## Addendum No. 1

**Project:** Salem Community Schools  
2021 FEMA Safe Room Additions

**Date:** April 9, 2021

**Project No.:** 202020.01/02

Item 10: Refer to Volume 2 Sheet P501.

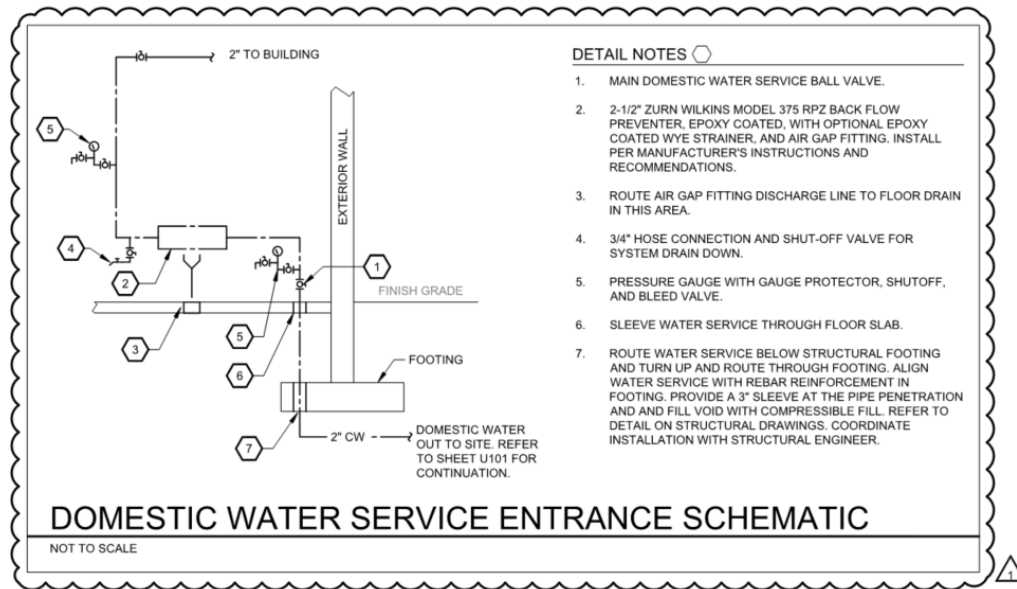
- B. Refer to PUMP SCHEDULE: revise pump schedule as follows:

PUMP SCHEDULE											
MARK	MANUFACTURER	MODEL	LOCATION	FLOW (GPM)	HEAD (FT)	RPM	CONNECTIONS		ELECTRICAL		REMARKS
							INLET	OUTLET	HP	V / Ø / Hz	
RP-01	TACO	0011-SF4	CUSTODIAN B111	5	12	3250	3/4"	3/4"	FRACT.	115/1/60	ALL
REMARKS: 1. STAINLESS STEEL CASING WITH STAINLESS STEEL CARTRIDGE. 2. 100% LEAD FREE. 3. INSTALL WITH SHAFT IN A HORIZONTAL POSITION. OTHER ACCEPTABLE MANUFACTURERS INCLUDE: WILO, B&G, GRUNDFOS. REFER TO SPECIFICATIONS FOR ADDITIONAL REQUIREMENTS.

Item 19: Refer to Volume 1 Sheet M501.

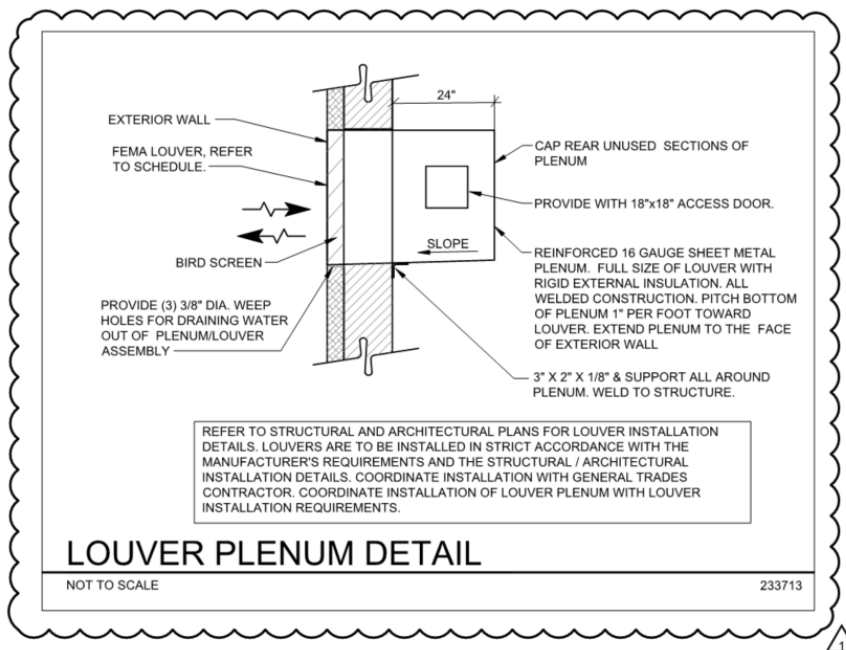
- A. Add the following detail:

D. Omit VERTICAL ENERGY RECOVERY VENTILATOR DETAIL (ERV-1, 2)

E. Refer to DIFFERENTIAL PRESSURE TRANSDUCER DETAIL:

- a. Note identifying differential pressure device shall be revised to read as follows:  
VERIS PWLX04S DIFFERENTIAL PRESSURE TRANSDUCER PROVIDED BY TCC. REFER TO PLANS FOR LOCATION.

Item 23: Refer to Volume 2 Sheet M501.

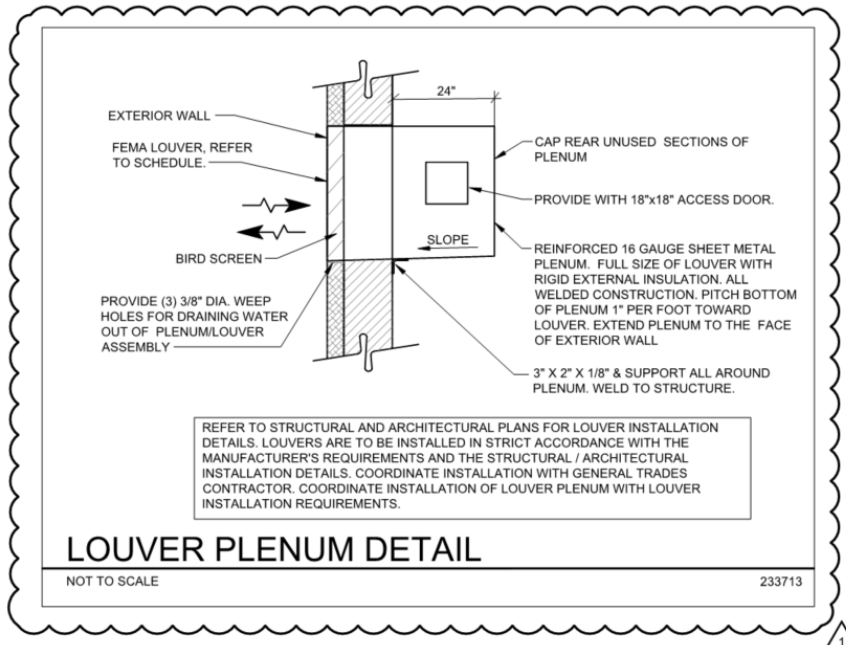
A. Add the following detail:

Item 7: Refer to attached revised Volume 2 Sheet U101.

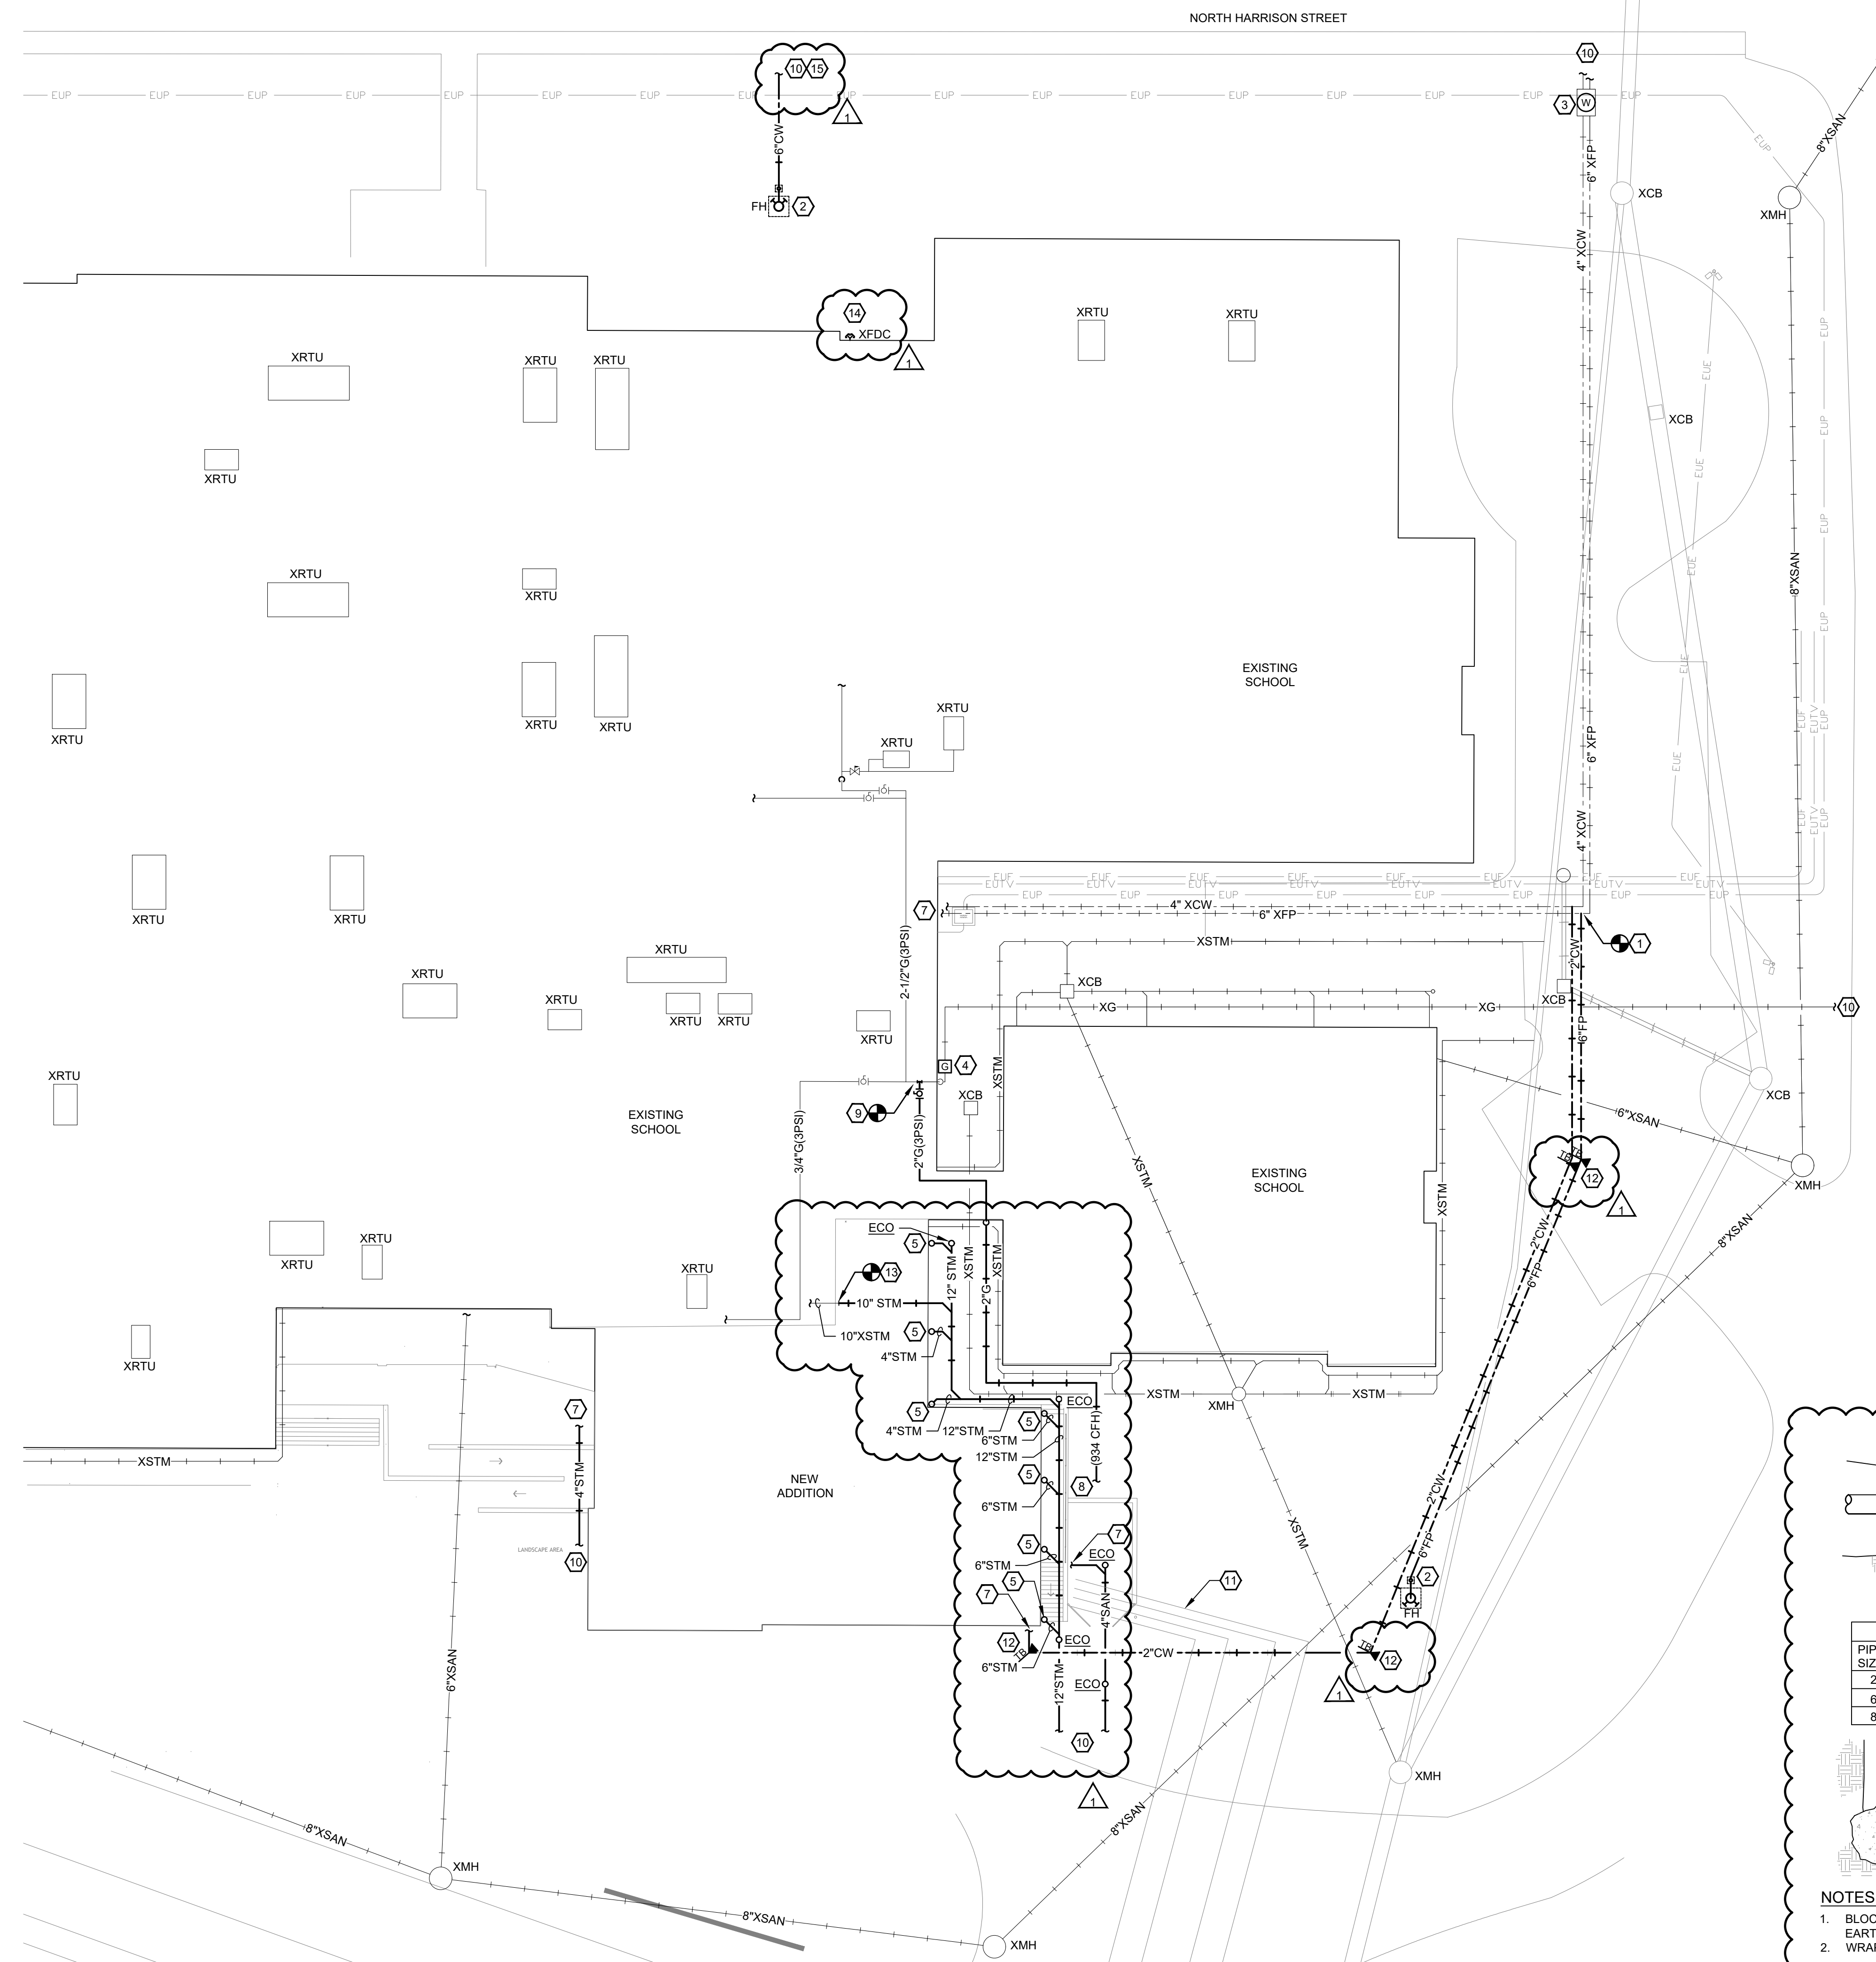
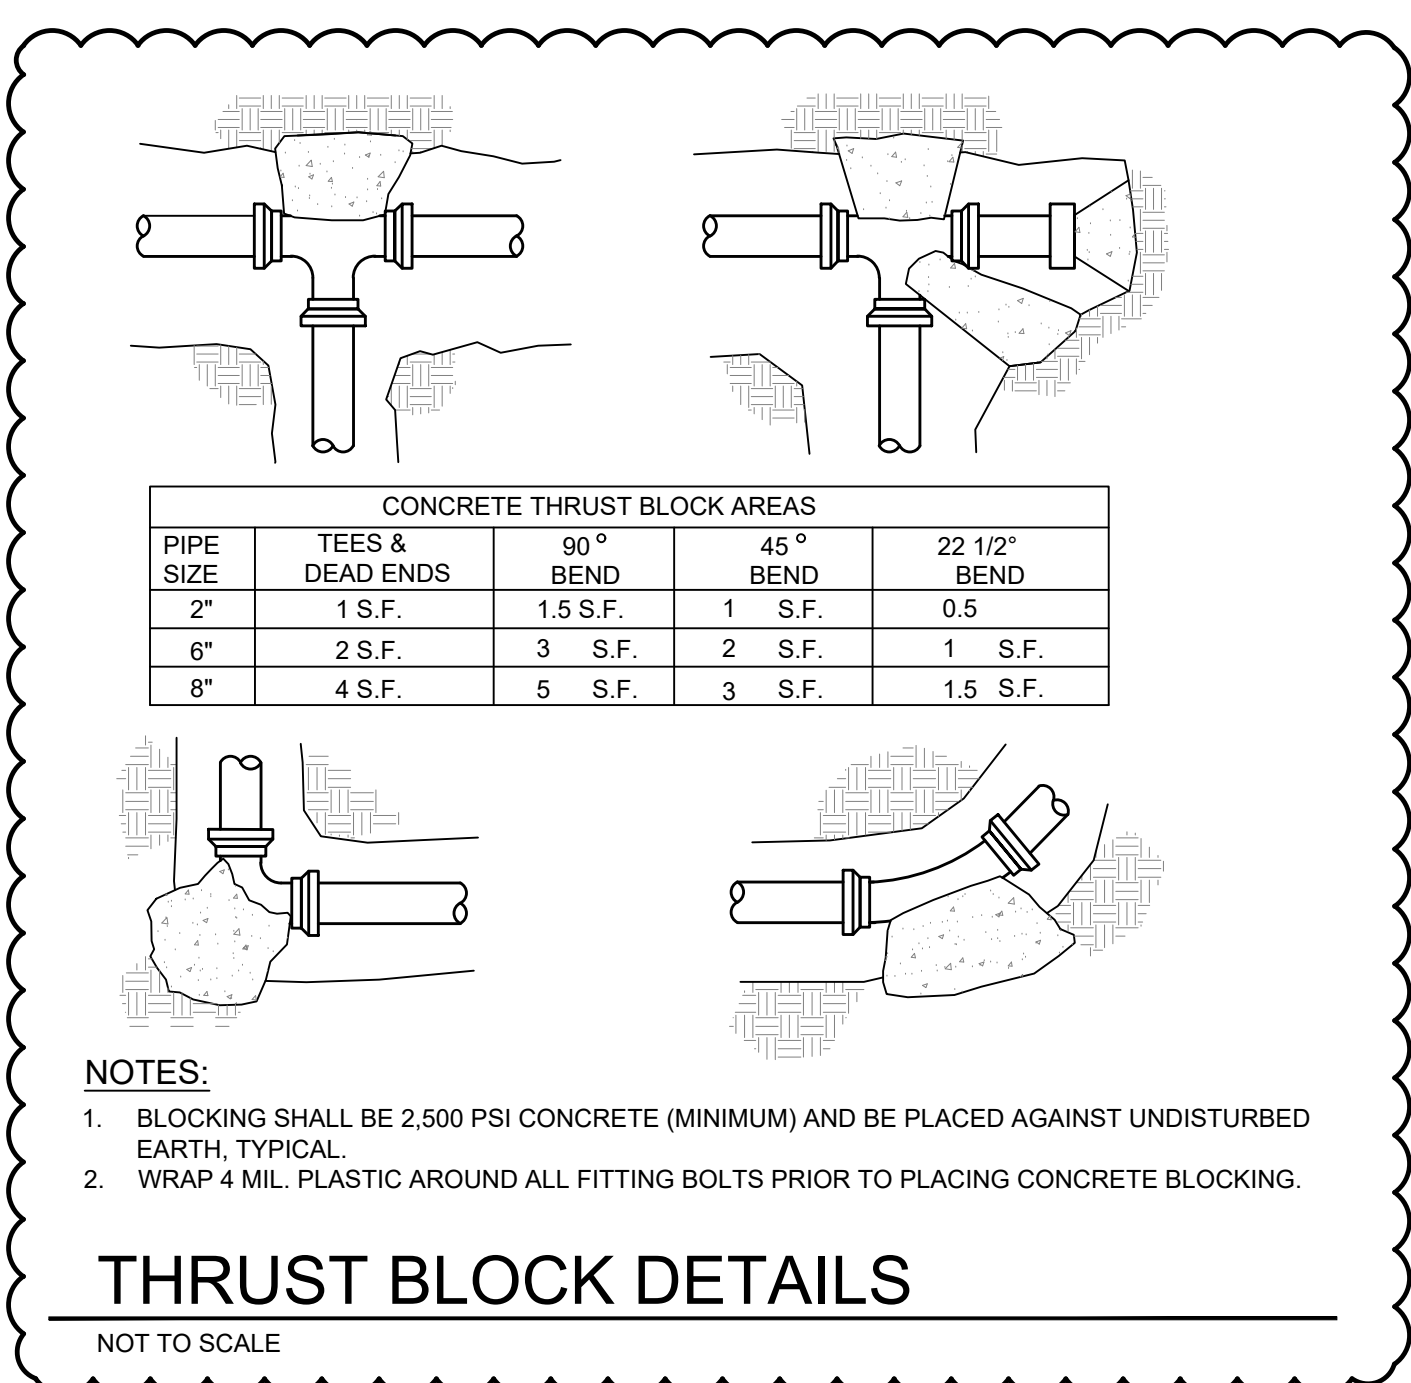
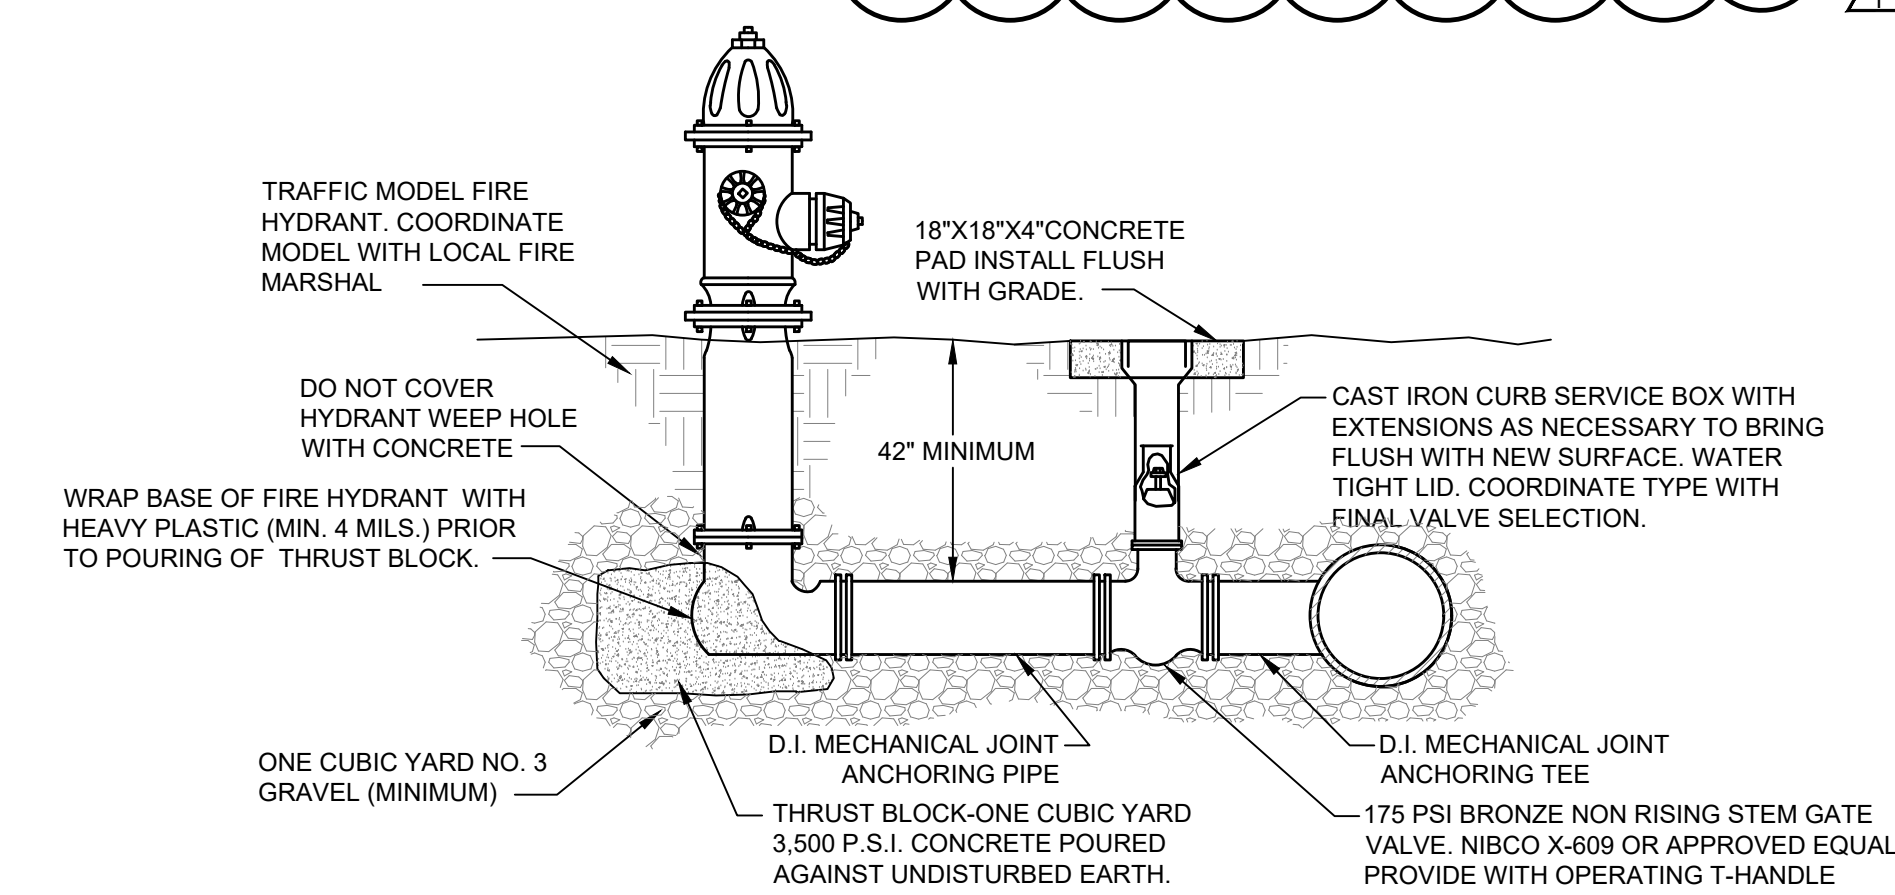
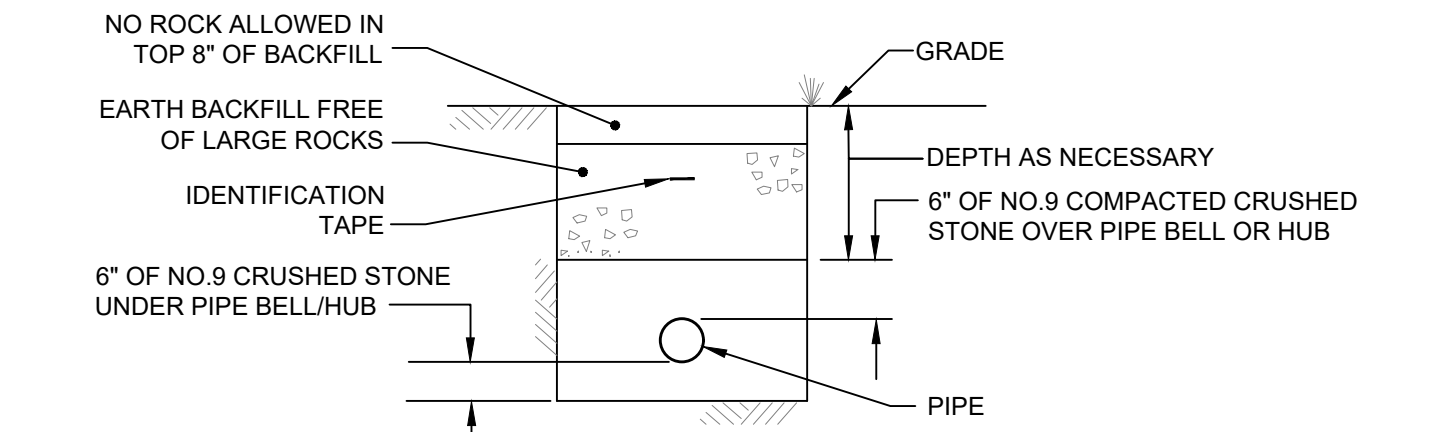
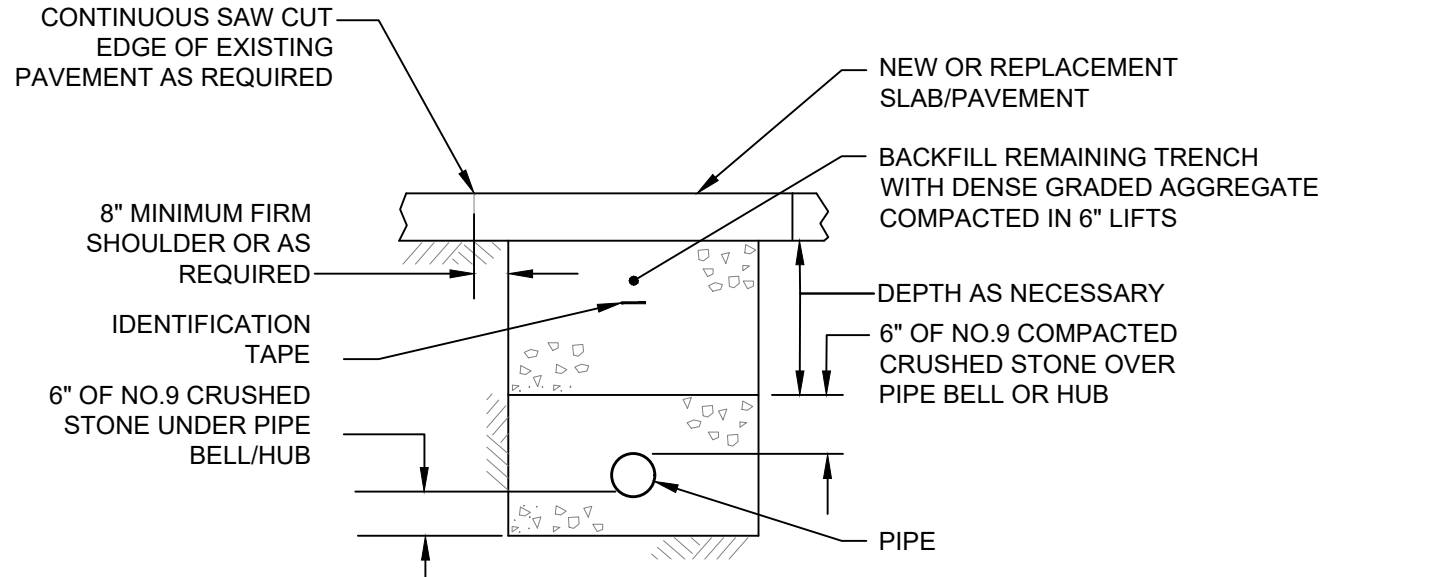
- B. Storm Drain Piping:
  - a. Scope has been added to connect to existing 10" storm drain leaving Classroom 102.
  - b. Storm drain main has been upsized to 12".
- C. Sanitary Piping: cleanouts have been added.
- D. Water/Fire Protection Piping Mains: thrust blocks have been added (detail added on this sheet).
- E. Additional keynote revisions.
